# DSOX3012A-03

## S E R V I C E N O T E

DSOX3012A – Oscilloscope, Mixed Signal, 2 Channel,  
100MHz

**With the oscilloscope’s power on and while under normal operation the unit emits a hissing noise.**

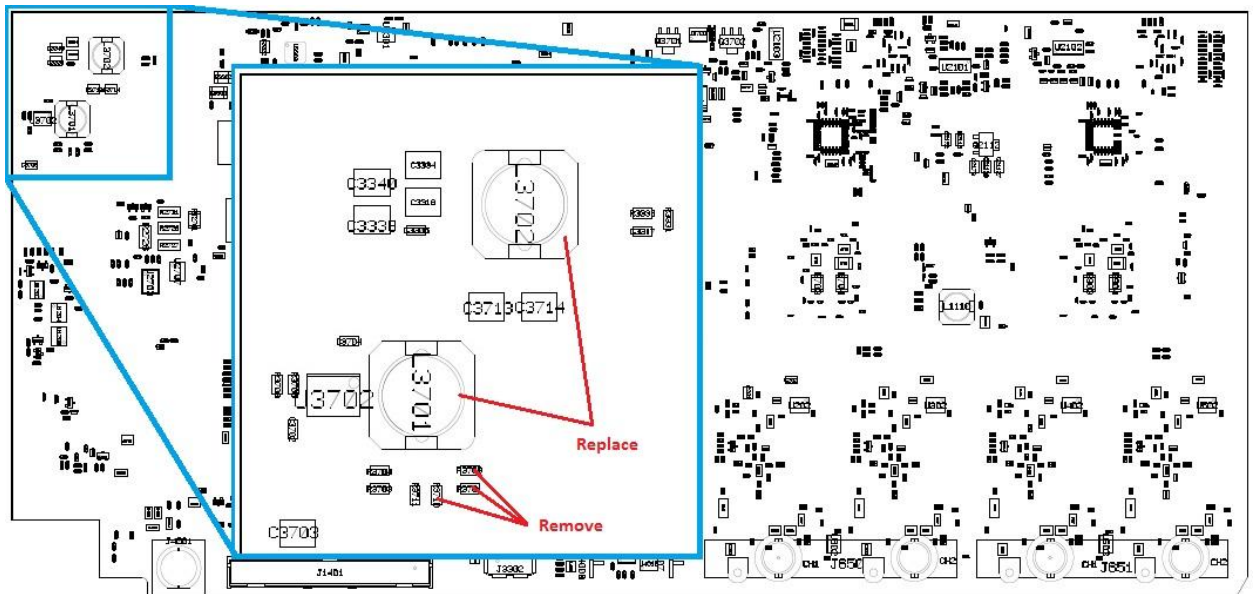
With the oscilloscope power turned on and while under normal operation, the unit emits a hissing noise.

2. As the picture indicates, remove the three resistors (0699-7209, 1 Ohm) located at R3701, R3709, and R3710. They are not to be replaced.
3. Remove as well the two inductors (9140-6474, 100uH) located at L3701 and L3702 and replace them with inductors with part number 9140-6151 (68 uH).
4. Re-assemble to the point where the unit could be powered up to verify that the hissing is indeed gone. If the hissing is not gone, please, check modifications.
5. When the hissing is gone, put oscilloscope back together.
